**Bid #CA23-2526**  
**WEST VALLEY-MISSION COMMUNITY COLLEGE**  
**DISTRICT**  
**WV STEM CLASSROOM HVAC UPGRADES**

**BID ADDENDUM NO. 1**

**PROJECT:** WEST VALLEY COLLEGE  
WV STEM CLASSROOM HVAC UPGRADES  
14000 Fruitvale Avenue  
Saratoga, CA95070

**ADDENDUM DATE:** May 13<sup>th</sup>, 2026

**M501**

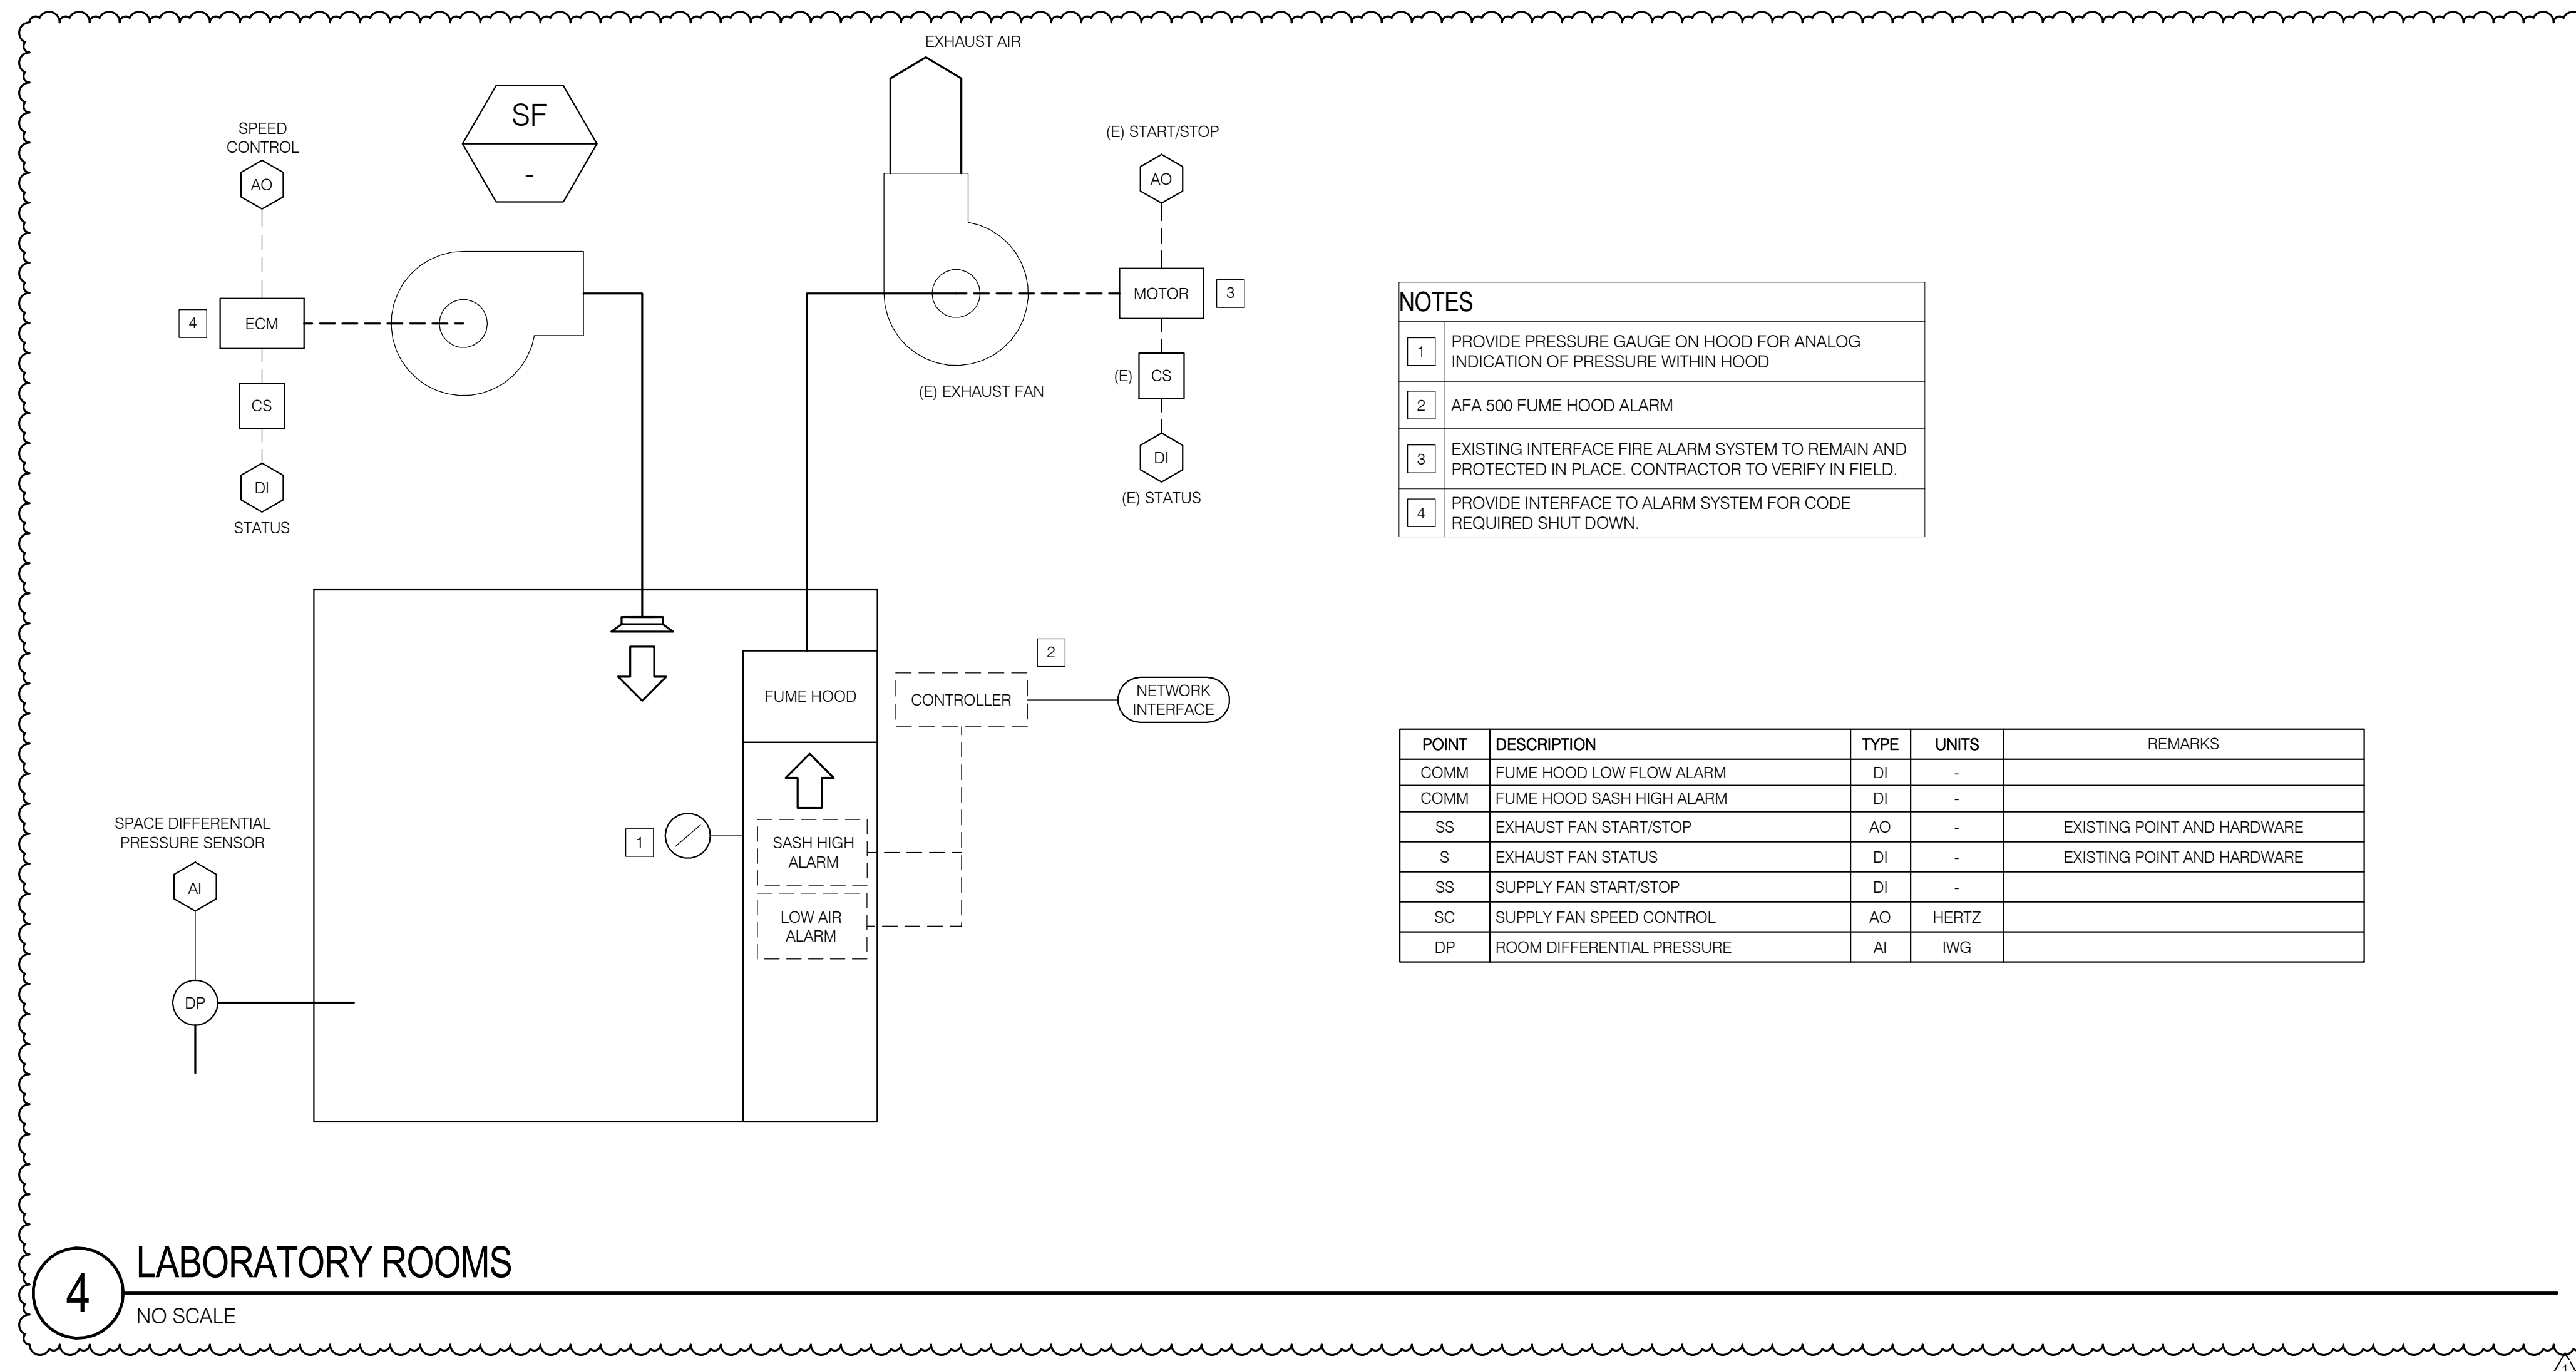
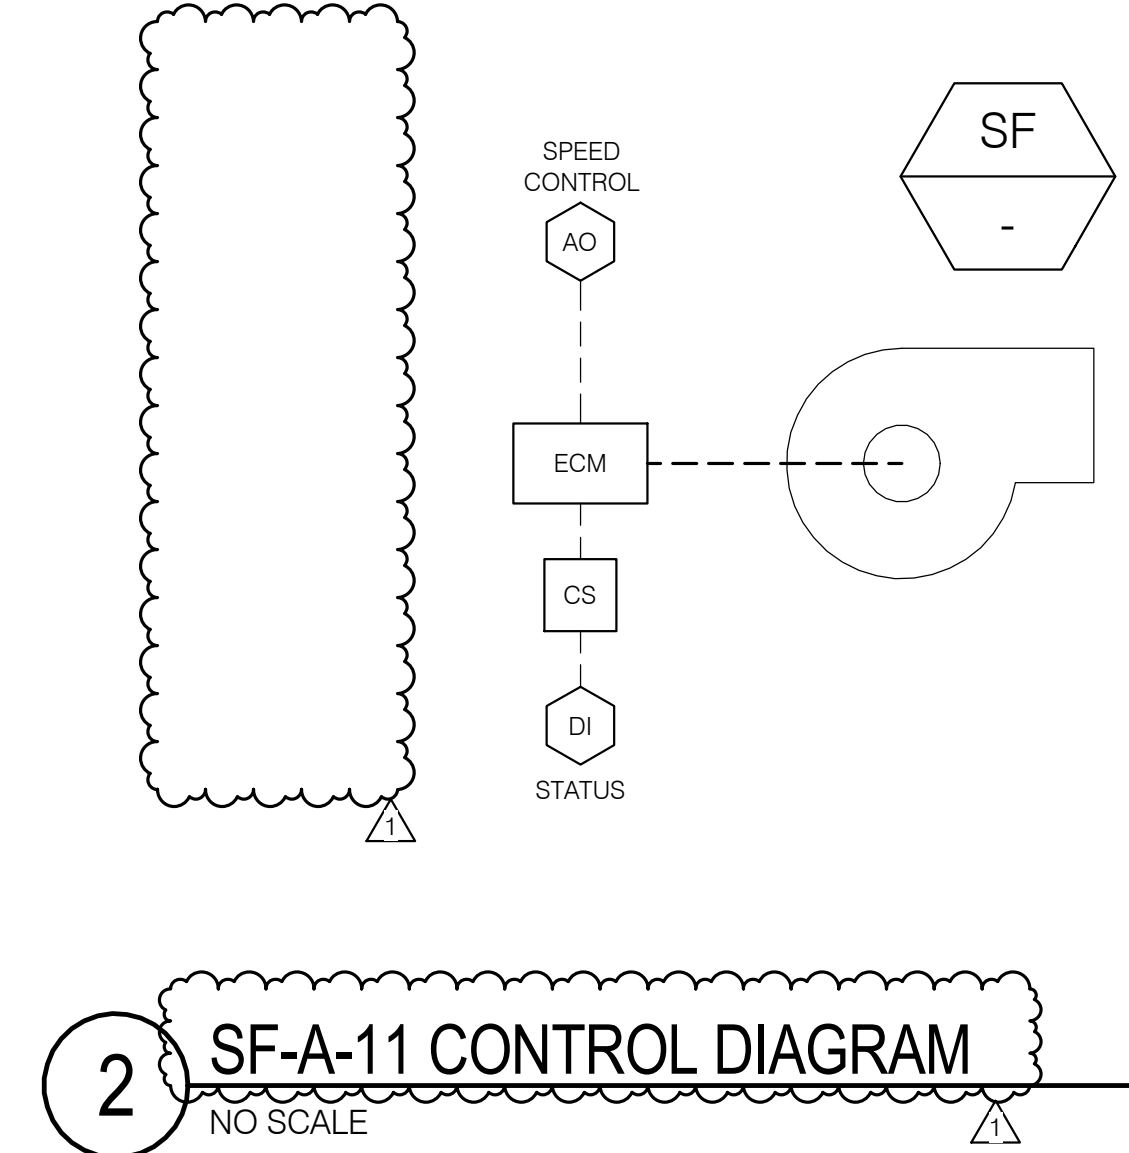
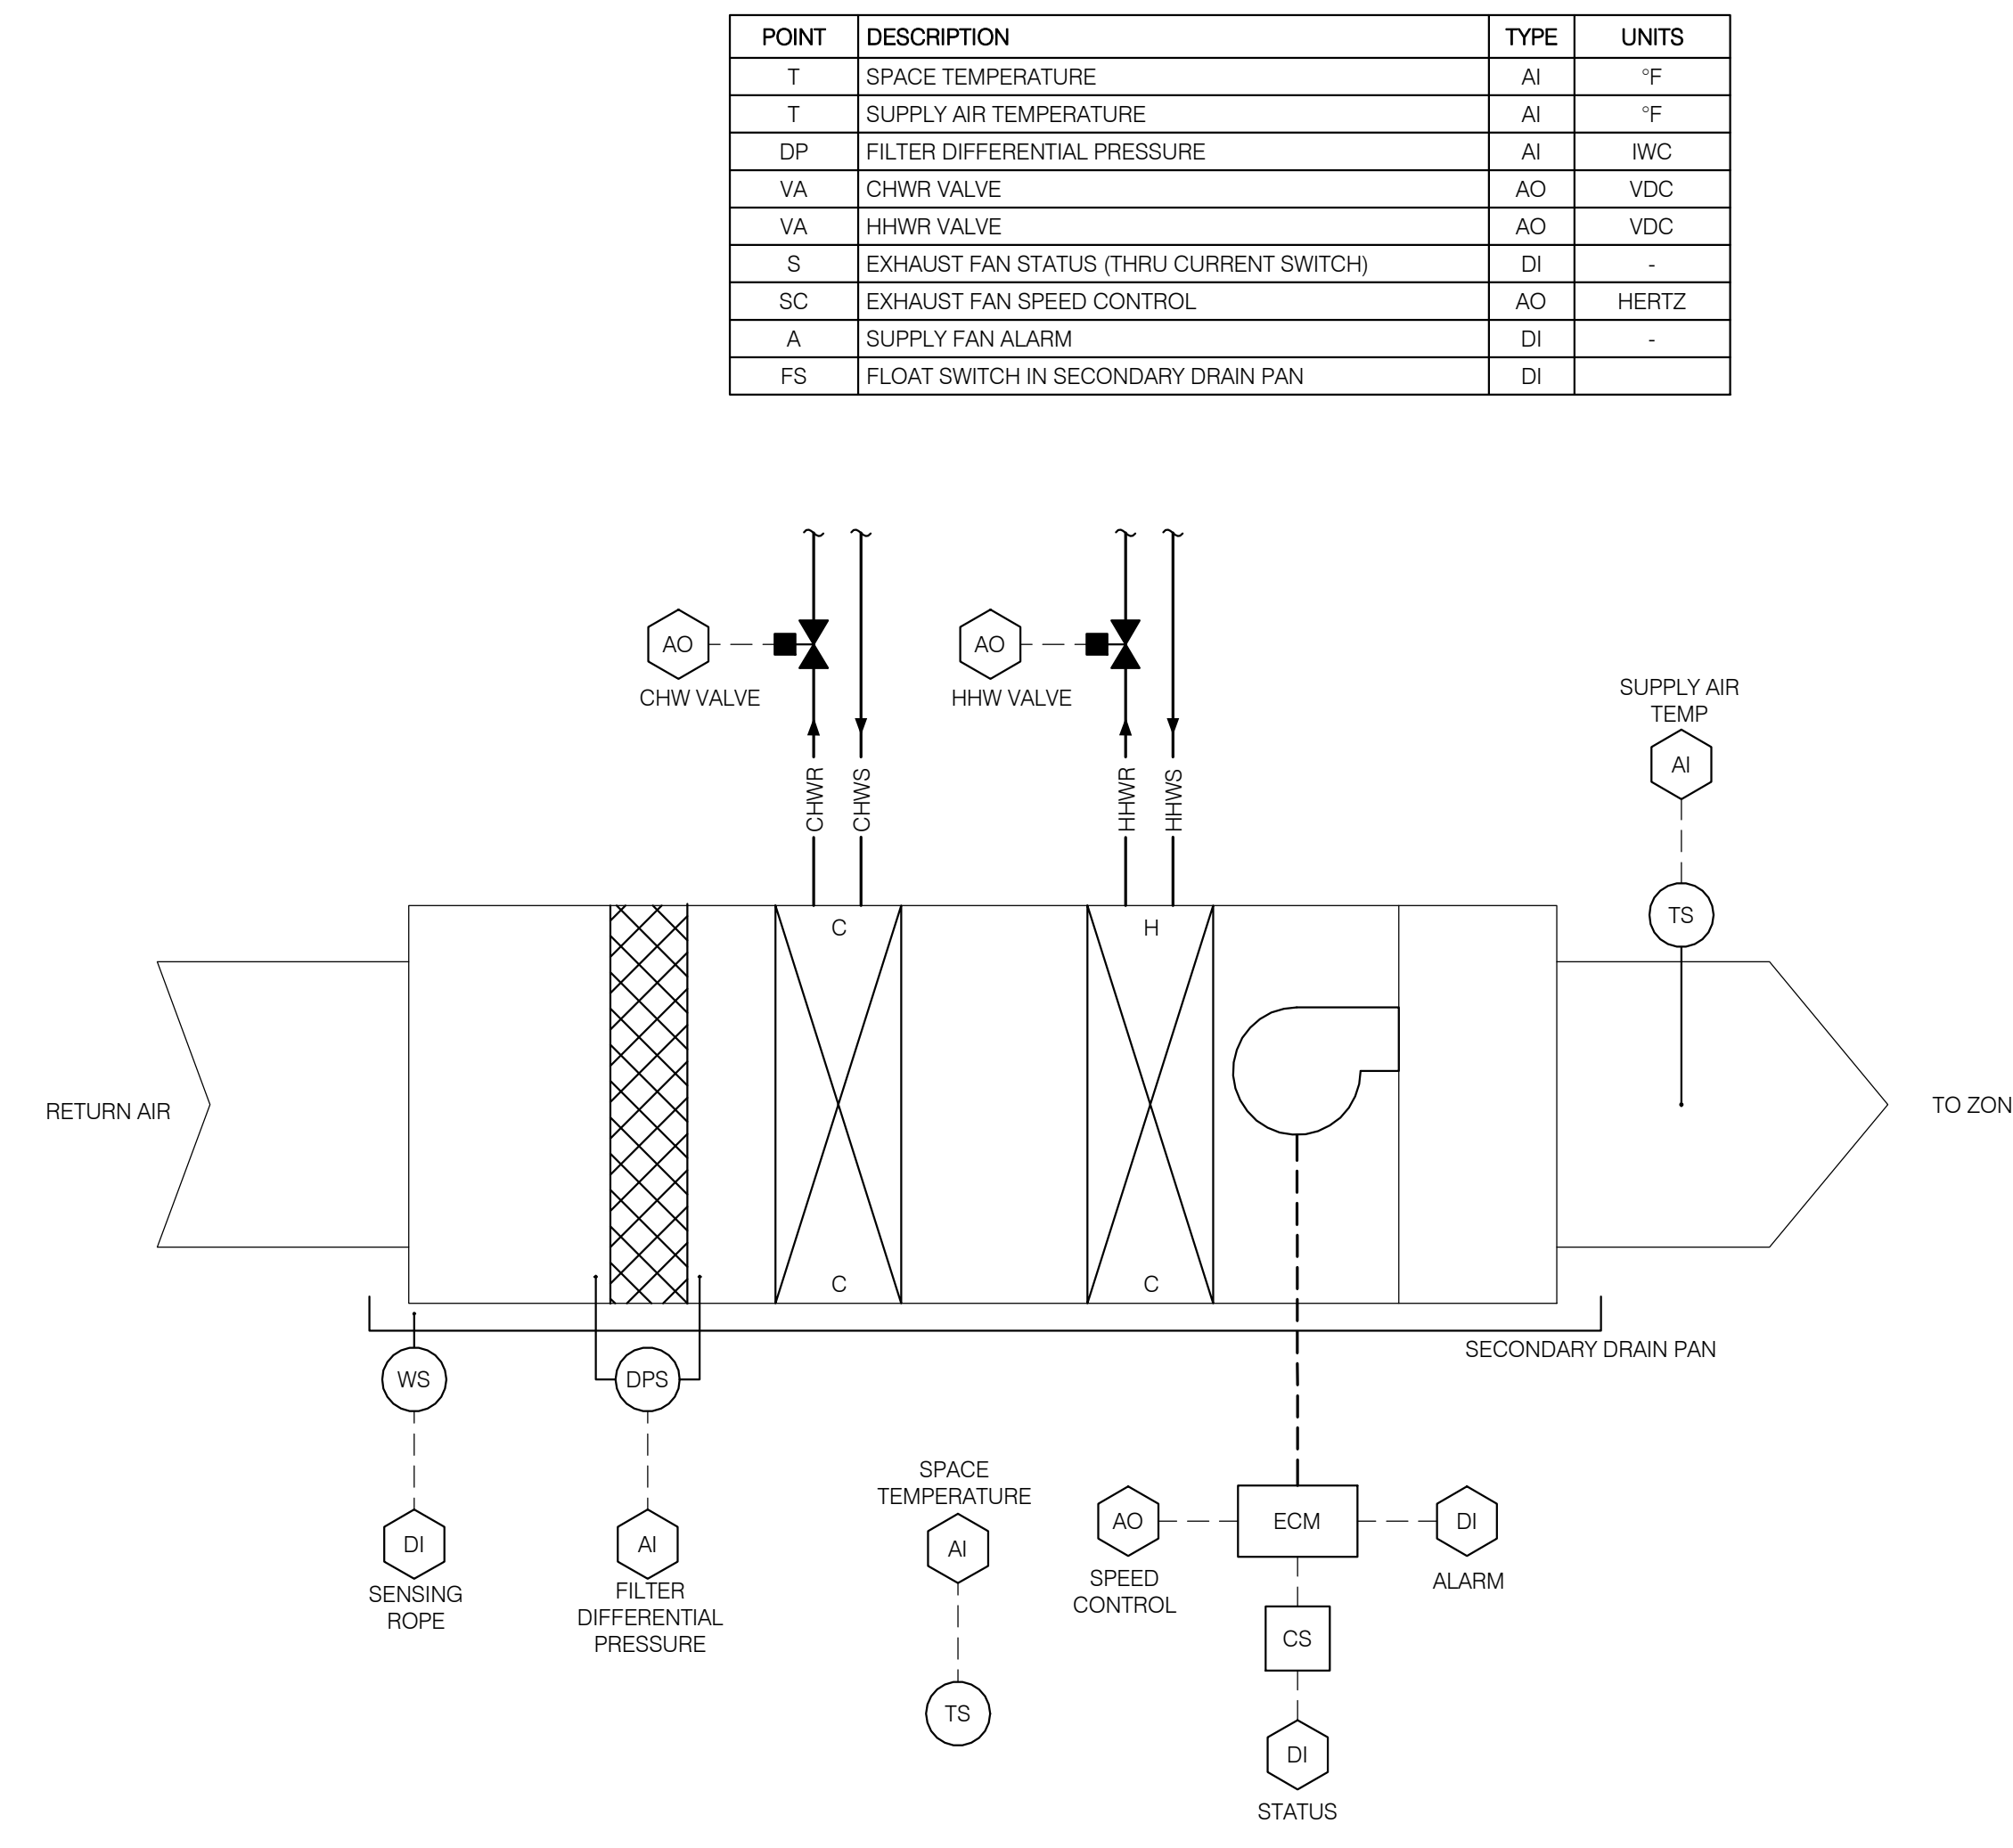
- NOTES**
- 1 PROVIDE PRESSURE GAUGE ON HOOD FOR ANALOG INDICATION OF PRESSURE WITHIN HOOD.
  - 2 AFA 800 FUME HOOD ALARM
  - 3 EXISTING INTERFACE FIRE ALARM SYSTEM TO REMAIN AND PROTECTED IN PLACE. CONTRACTOR TO VERIFY IN FIELD.
  - 4 PROVIDE INTERFACE TO ALARM SYSTEM FOR CODE REQUIRED SHUT DOWN.
